1 Q. RE: p. B-21 Purchase and Install Closed Circuit Surveillance System –
2 Holyrood (\$152,000)

1 Q. RE: p. B-25 Pave Parking Area - Bishop's Falls Complex (\$69,000)

1 Q. RE: p. B-25 Upgrade – TL 227 – (69 kV Berry Hill – Daniel’s Harbour)
2 (\$496,000)

FIGURE 1
OVERALL STRUCTURE OF THE HYDRO GROUP'S EMS

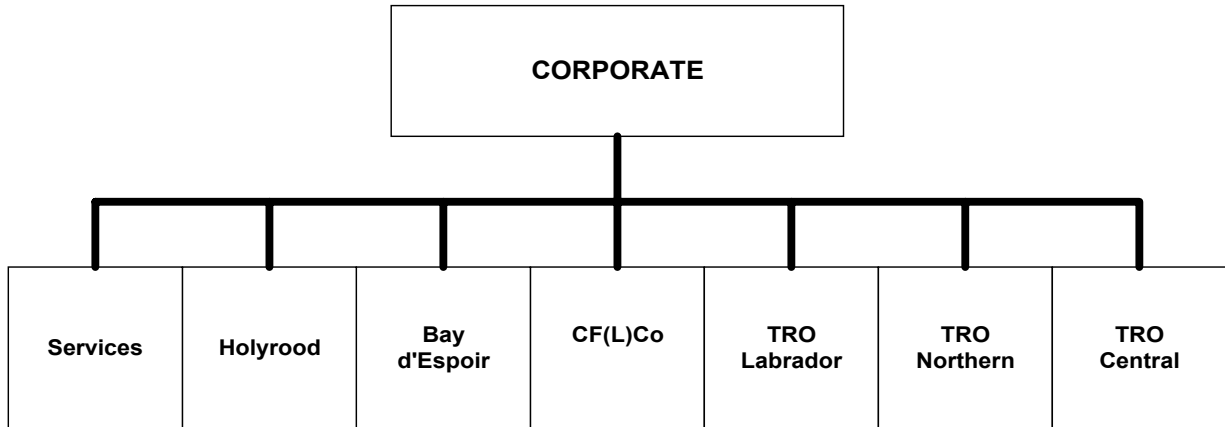
7 64.2 Describe the Environmental Management System. (WEW, p. 21, lines
8 17–19).

14
15 The Hydro Group's strategy for EMS development is to provide overall
16 policy and procedural guidance from corporate headquarters and to
17 delegate the development of specific environmental management
18 systems to each of the Hydro Group's seven "management areas."
19 The seven management areas (Figure 1) reflect our organizational
20 structure. They include our three primary power production
21 operations, our three transmission and rural operations regions, and
22 our support services.
